CITY OF HAM LAKE PLANNING COMMISSION AGENDA MONDAY, APRIL 26, 2021

Date: April 22, 2021
To: Planning Commissioners
From: Tom Collins, City Engineer *TPC*
Subject: Crosstown Rolling Acres Third Addition

The Preliminary Plat, Grading, Erosion Control and Tree Protection Plan, Livability Plan, Street and Storm Sewer Profiles, Stormwater Sizing & Location Plan, Details, Stormwater Drainage Report and Stormwater Pollution Prevention Plan were received March 25th, the revised Title Sheet T1 and Street Plan and Profile sheets C1.4 and C1.5 and revised storm sewer sizing calculations were received on March 31st and the revised Preliminary Plat Sheet 1 and Grading, Erosion Control and Tree Protection Plan Sheets 4 and 5 were received on April 22nd for the proposed 49 lot residential development located on 102.6 non-contiguous acres of parcels 06-32-23-32-0002, 06-32-23-34-0002, 06-32-23-34-0004, 06-32-23-43-0002, 06-32-23-43-0005, 06-32-23-43-0006 and 06-32-23-44-0011. The Third Addition is a portion of the overall Crosstown Rolling Acres plan that received Sketch Plan approval at the February 5, 2018 City Council meeting. The parcels are currently zoned Rural Single Family Residential (R

PRELIMINARY TURN LANE PLAN

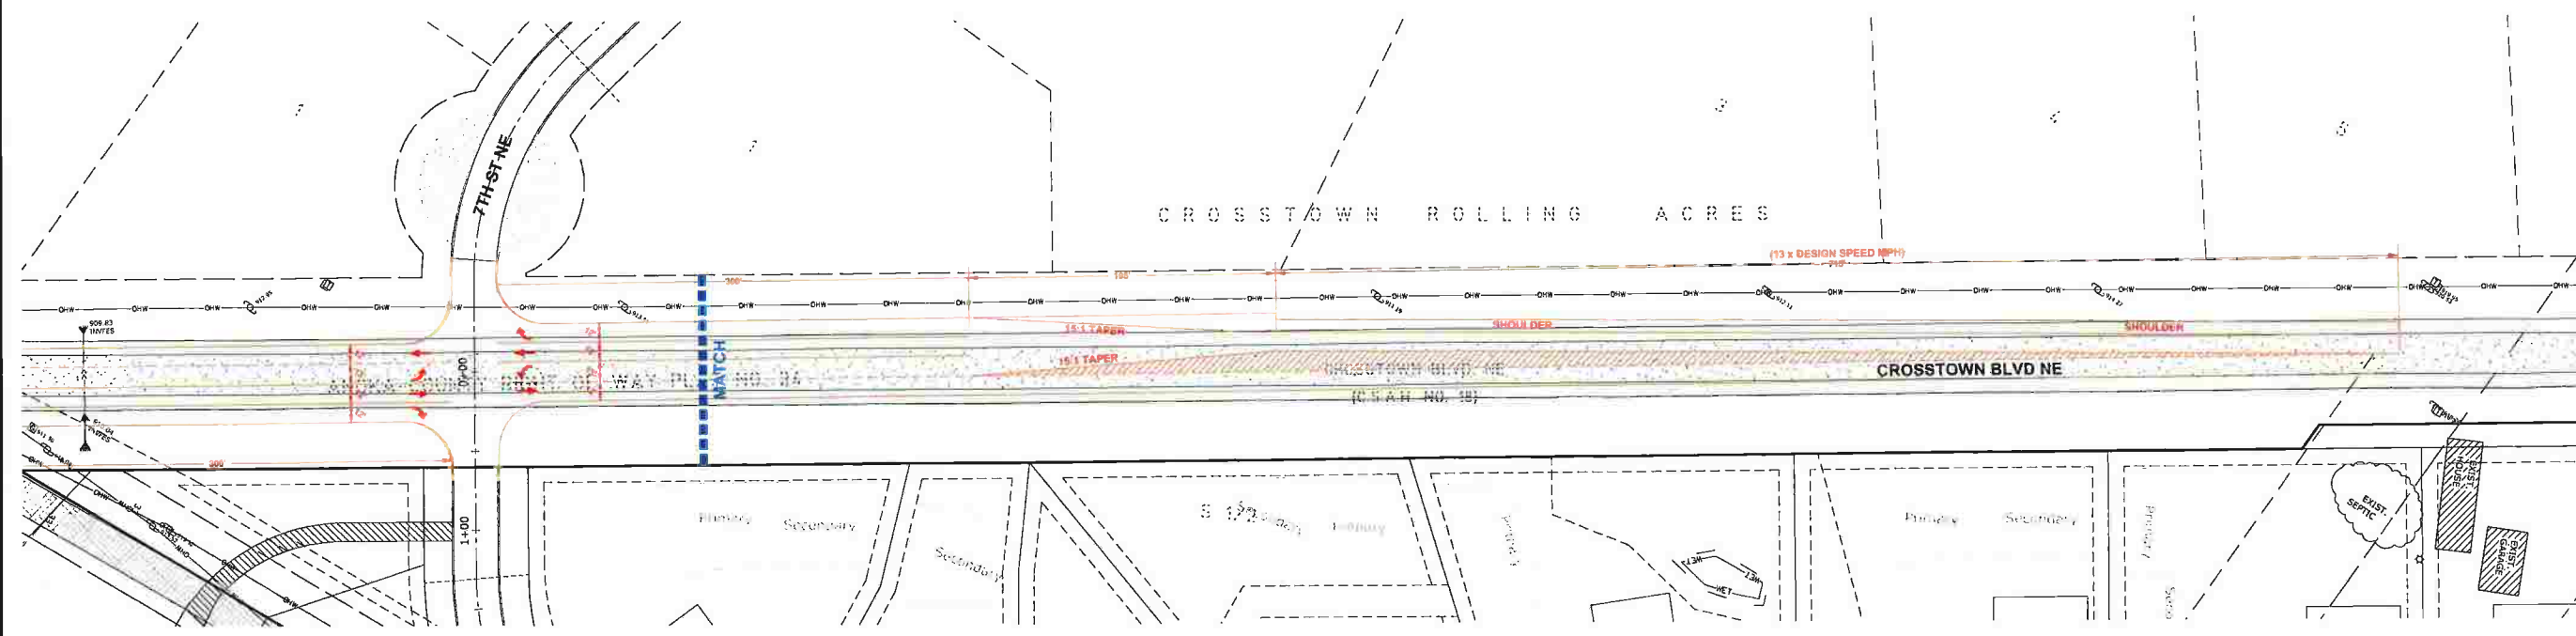
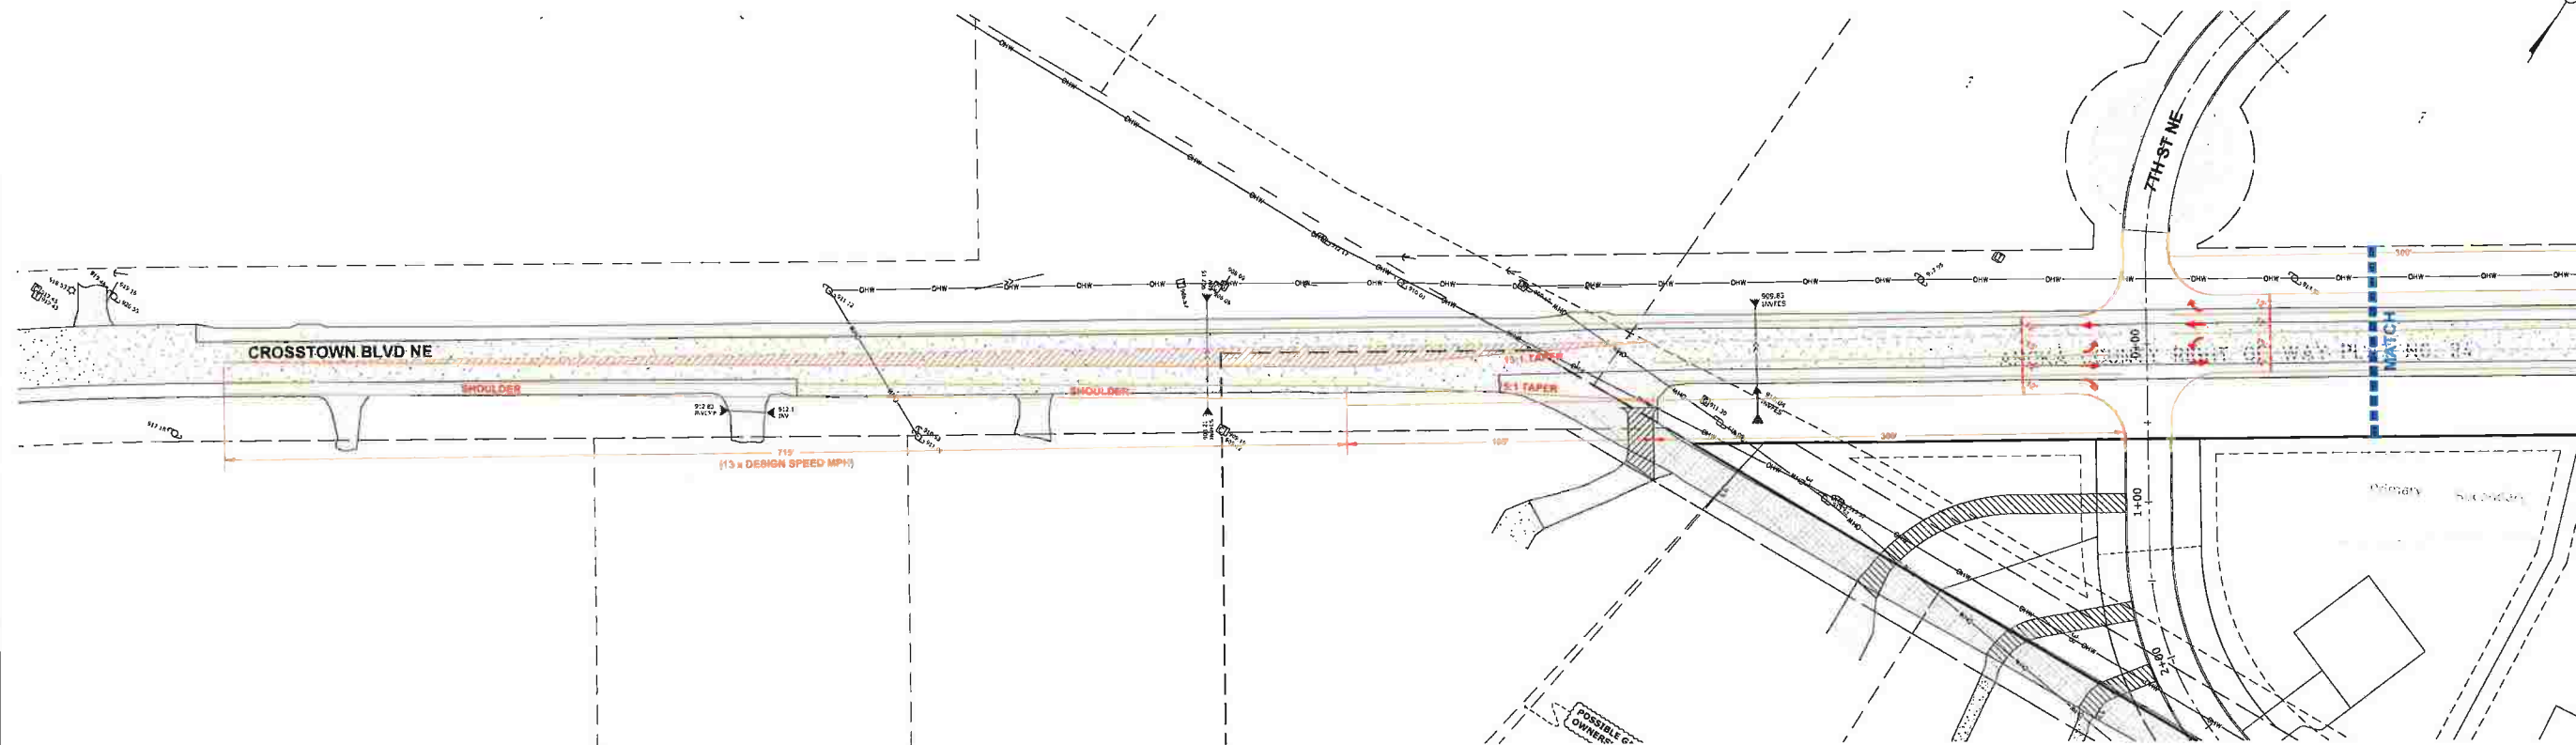
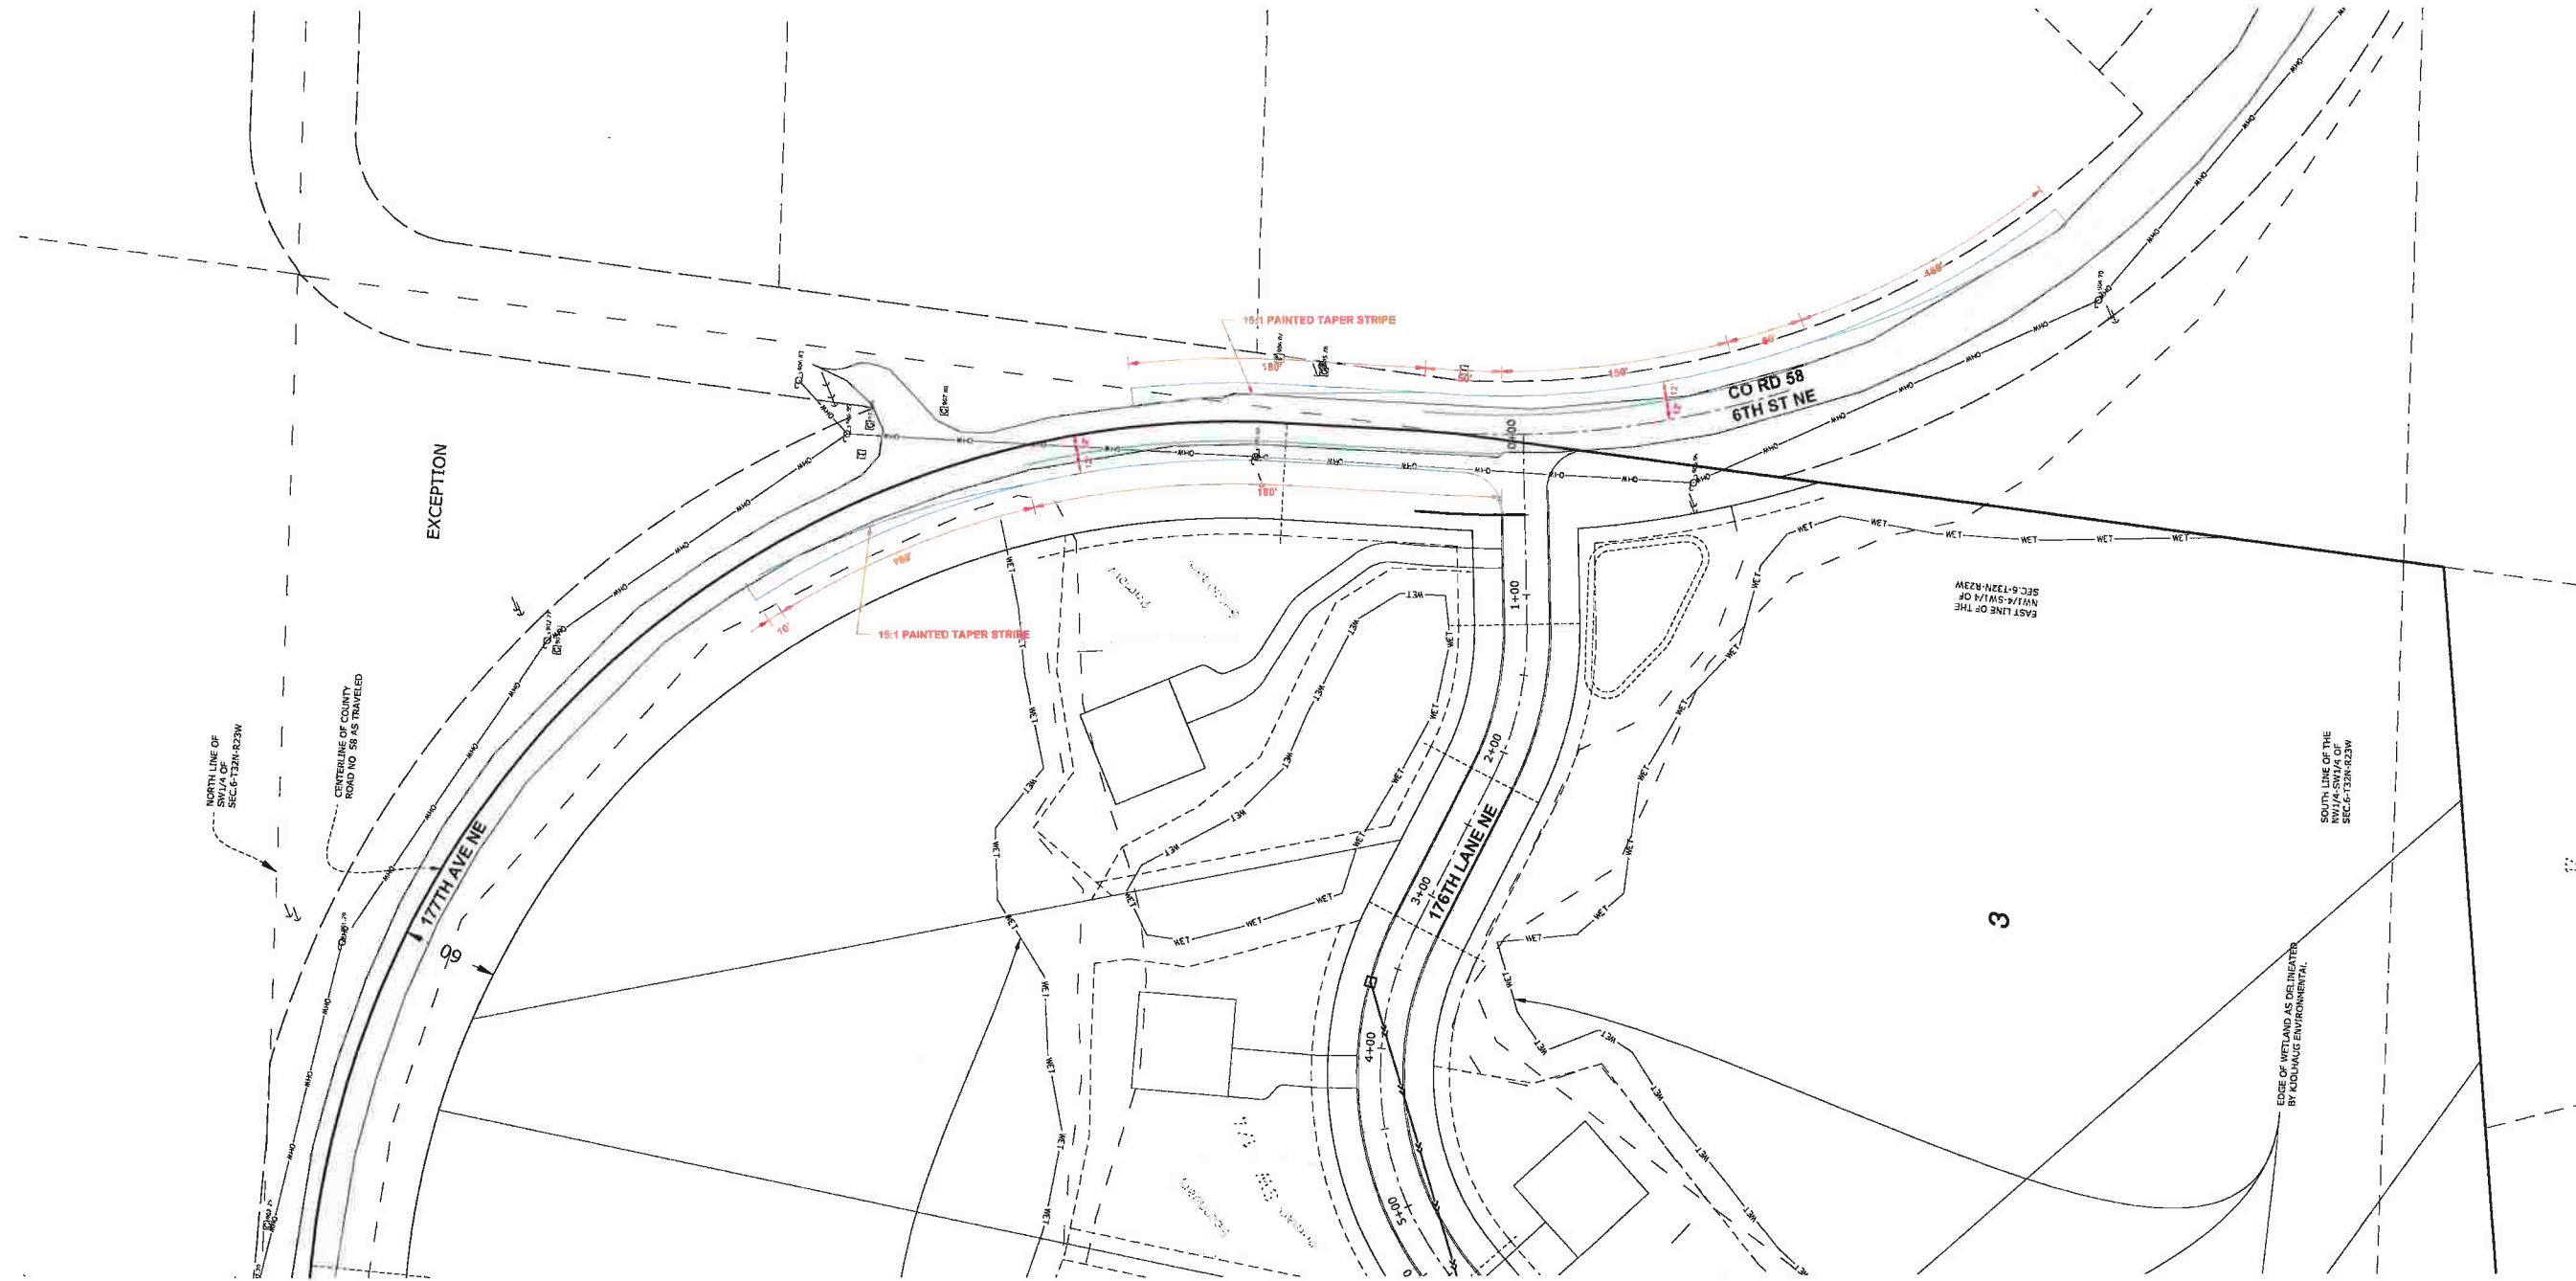
The Coon Creek Watershed District conditionally approved the development at the March 22nd Board of Managers meeting. The Anoka County Highway Department has not completed their review. Per the attached Preliminary Turn Lane Plan, it is anticipated that the improvements to Crosstown Boulevard include the 7th Street connection from the Crosstown Rolling Acres Second Addition and construction of both east bound and west bound left and right turn lanes at 7th Street. The anticipated improvements to County Road 58 include removal of the 173rd Lane intersection and construction of a southbound right turn lane and a northbound bypass lane.

That said, we do share your concern about the excessive cross-slope and would ask them to provide an engineering justification for it. I think we'd want to see a superelevation plan, and they would need to update the typical section to match what they are actually proposing.

We are reviewing the latest plan set from Plowe regarding Crosstown Rolling Acres 3rd Addition. Plowe has stated plans were supplied to Anoka County on 3/15. There is enough information for the proposed intersection of 176th Lane NE and CSAH 58 that has raised a question.

They are showing an existing 7.3% superelevation of CSAH 58 at the intersection. They are showing a 0.9% slope sloping away from the curve. The plan shows an algebraic difference of 8.2% which exceeds the maximum 7% algebraic difference between the through-lane slope and the shoulder slope and also which is less than the minimum 1% required for the shoulder.

Their typical also doesn't describe the slope conditions of the turn lane, if they are to match the superelevation or if they are to provide the 2% grade as suggested.
